<b>TempNo.</b>	<b>PI</b>	<b>Topic</b>	<b>Status</b>	<b>Plant/ Co.</b>
76.0	IE03	Discovery of an Off-normal condition	1/16 Introduced and discussed 2/20 Discussed 3/19 Discussed 4/16 Tentative Approval	Quad Cities

FAQ 76.0

Performance Indicator: Unplanned Power Changes per 7,000 Critical Hours

Plant: Salem Generating Station Unit 1  
Date of Event: April 22, 2007 and April 29, 2007  
Submittal Date: November 14, 2007  
Licensee Contact: Brian Thomas Tel/email: 856-339-2022/brian.thomas@pseg.com  
NRC Contact: Dan Schroeder Tel/email: 856-935-5151/ DLS@NRC.gov

Attachment 2

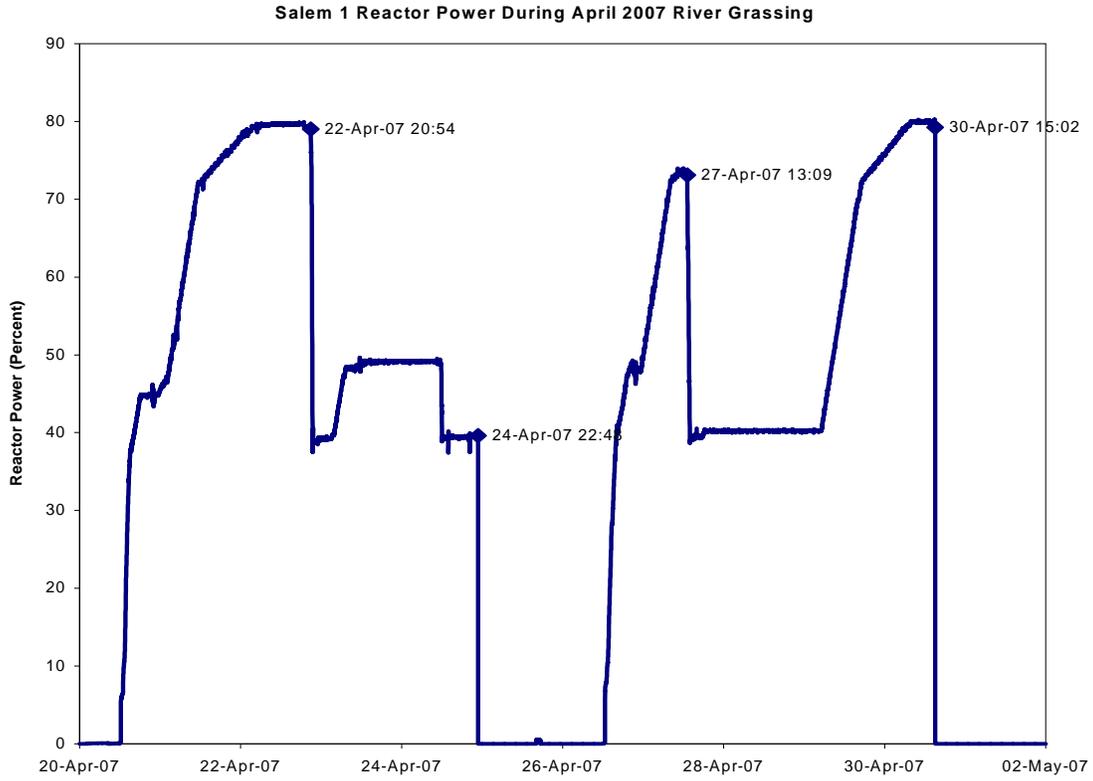
On April 20, 2007 Salem Unit 1 began its return to power from its 18<sup>th</sup> refueling outage. During the power ascension, circulating water pumps were being removed from service in accordance with procedures to clear the traveling water screens and to clean the condenser water boxes of debris. On April 22, 2007 a power level of 80% was reached. A greater than anticipated influx of marine debris/grassing occurred causing circulating water pumps to be shutdown. The delta temperatures across the condenser began to increase and power was reduced to approximately 40% power in accordance with abnormal operating procedures to maintain condenser outlet temperatures below established limits. When monitoring and predictions indicated a reduced grass level, power was increased to 48% on April 23, 2007 where it remained for approximately one day for continued monitoring of grassing levels. On April 24, 2007 grass levels increased again requiring a downpower to 40%. Late on April 24, 2007 Salem Unit 1 was manually tripped by procedure due to the tripping of several circulating water pumps as a result of an influx of marine debris/grassing. [This was counted as a reactor shutdown] (See Attachment 2 for Power-History curve)

The charts below summarize the key data. They include three plots:

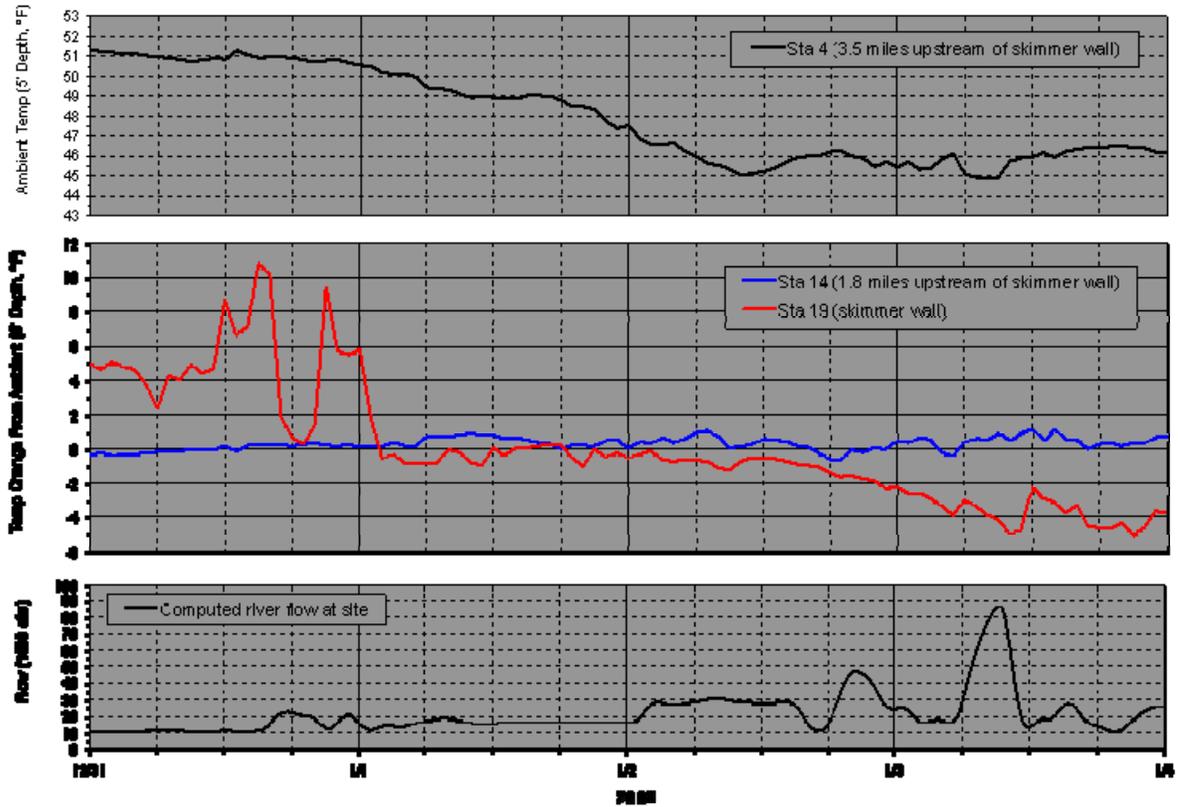
Due to a cold front entering the valley (and a consequent increase in system power demand), hydro generation "picked-up" late in the afternoon of December 31, 2007. As a result, river flow was increased from 10,000 cfs to between 16,000 cfs and 20,000 cfs. This river flow was sufficient to "push" the pool of warm water downstream of the plant intake skimmer wall. In the early hours of 1/1/08, this eliminated the 4°F to 8°F "swell" in river temperature noted above (see Station 19 plot). At the same time, the cold front also reduced the temperature of the ambient river water by about 5 F, from about 51°F on December 31, 2007 to about 46°F on January 2, 2008. Thus, the aquatic wildlife in the vicinity of the intake was exposed to a total temperature drop of between 9°F and 13°F within about 24 to 36 hours. Most likely, this is what "stunned" the shad, making them lethargic.

Late in the day on January 2, 2008, hydro peaking operations produced peak river flows near 47,000 cfs, lowering the water temperature at Station 19 (i.e., intake skimmer wall) 2°F below the ambient temperature. Late in the morning on January 3, 2008, hydro power peaking operations produced peak river flows near 87,000 cfs, lowering the water temperature at Station 19 another 2°F (a total of about 4°F below the ambient temperature). In these events, the water entering the skimmer wall is below the ambient temperature because at high river flow, the plant withdrawal zone encompasses primarily the shallow overbank areas upstream of the intake. For extreme cold meteorology, the temperature of the water in these shallow areas will be colder than in the main channel of the river. At this point, however, the shad were probably already lethargic (due to the larger drop in temperature between late December 31, 2007 through January 2, 2008).

The downpowers, caused by environmental conditions and National Pollutant Discharge Elimination System (NPDES) restrictions for plant thermal discharge, were beyond the control of the licensee and could not be reasonably predicted greater than 72 hours in advance.

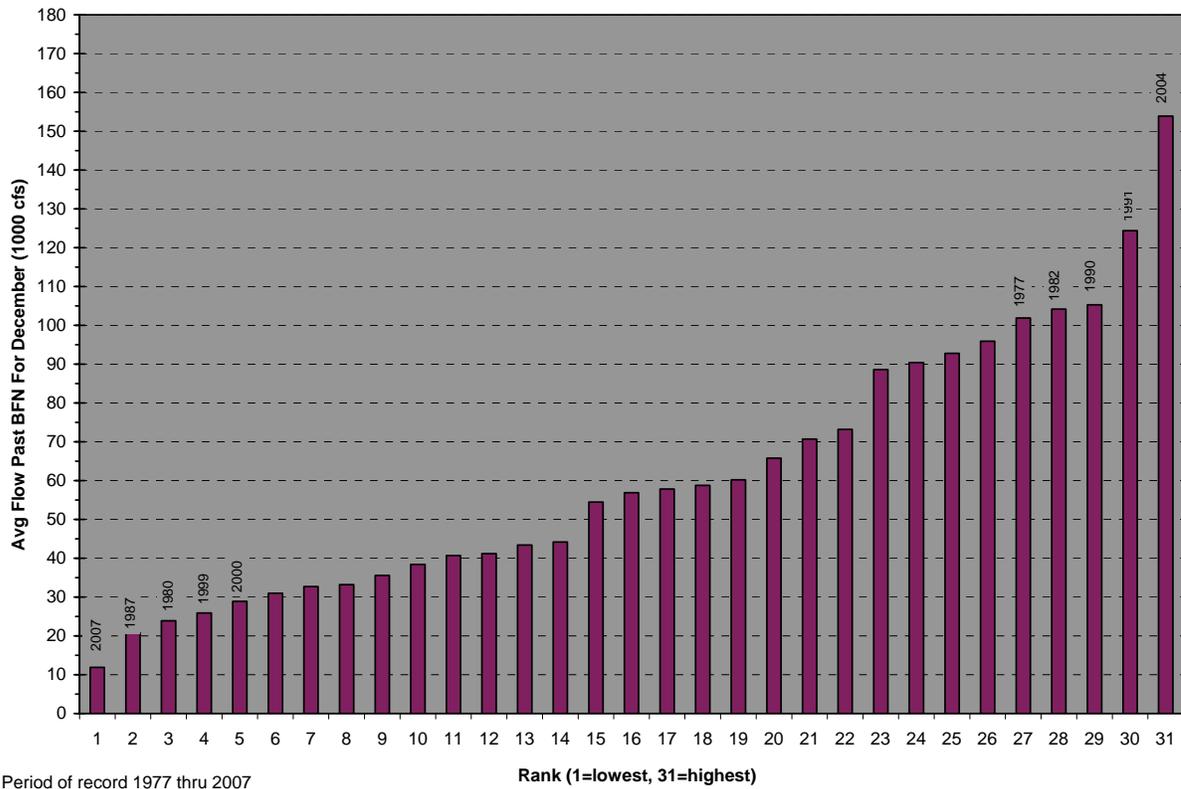
The drought conditions that existed in the Tennessee Valley during 2007 were most likely a contributing factor in the shad event. The drought conditions in the area were more severe this past year than any time previous in Brown Ferry's operational experience. River flows in the months preceding the event were well below normal. For example, the average river flow past the plant in December 2007 was the lowest in 31 years (see below).

In combination with the waste heat from the plant diffusers, this low flow would have created a larger than normal warm water sanctuary for the shad (e.g., because of low river flow, less heat was flushed downstream) establishing the conditions for a thermal shock event to occur.
